Cisco SIP IP Phone 7960 Version 1.0 Release Note

August 7, 2000

Admendments to the Documentation

Cisco SIP IP Phone-to-Cisco SIP IP Phone Simple Call Hold

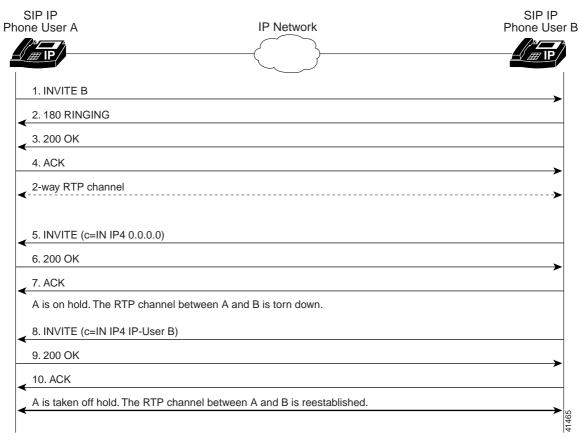
The documentation for the connection information (c=) SDP field in the INVITE messages of the following call flows in the *Cisco SIP IP Phone 7960* Administrator Guide has been changed:

As illustrated in Figure 1, to place the call on hold, IN IP4 0.0.0.0 is inserted into the c= SDP field of the INVITE message in step 5.

To reestablish the call between user A and user B, the IP address of User B is inserted into the c= SDP field of the INVITE message in Step 8. This reestablishes the 2-way RTP voice path between user A and user B.
